# Access Compliance Report

### (Curb Ramps)

Intersection ID: 10040560	Main Street: W_9TH_ST	Cross Street: N/A	Location: E
ADA ID: 857D9D32B9F1	Ramp Type: Perp	Initial Pass/Fail: Pass	Overall Compliance: No
		Severity Score: 5

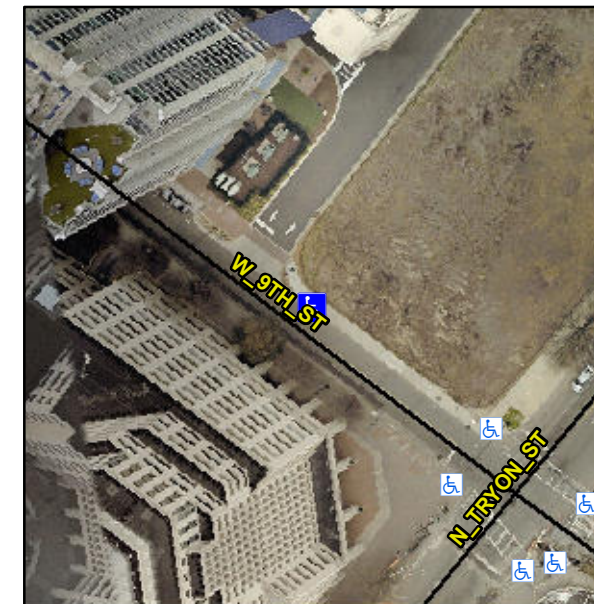
**R304.5.3, R304.2.3, R305.1.4,  
R302.7.2, R304.5.4**

Compliance	Description	Data	Compliance	Description	Data
N/A	Ramp Length (in)	105.0	Yes	Ramp Slope (%)	5.2
Yes	Ramp Width (in)	53.0	Yes	Ramp XSlope (%)	1.0
No	Flare Type	Curbed_WithWalkSurface	Yes	Flare Type RT	N/A
No	Flare Slope LT (%)	N/A	N/A	Flare Slope RT (%)	N/A
N/A	Flare Traversable LT?	No	N/A	Flare Traversable RT?	No
Yes	Landing Length (in)	60.0	Yes	DWS Provided?	Yes
Yes	Landing Width (in)	53.0	Yes	DWS Contrast?	Yes
Yes	Landing Slope (%)	0.5	No	DWS Length (in)	23.0
No	Landing X Slope (%)	2.1	Yes	DWS Full Width?	Yes
N/A	Landing Curb? (Y/N)	No	Yes	DWS Offset (in)	0.0
N/A	Shared Landing?	No			
Yes	Gutter Ponding?	No	No	Gutter Slope (%)	N/A
No	Gutter Lip Ht (in)	N/A	No	Gutter X Slope (%)	N/A
N/A	Painted X Walk1?	No	N/A	Painted X Walk2?	N/A
	X Walk 1 Direction	To W		X Walk 2 Direction	N/A
N/A	X Walk 1 Width (in)	N/A	N/A	X Walk 2 Width (in)	N/A
	X Walk 1 Slope (%)	2.3		X Walk 2 Slope (%)	N/A
	X Walk 1 X Slope (%)	0.7		X Walk 2 X Slope (%)	N/A

**Remove & Replace Entire Ramp.  
Remove & Replace Gutter.**
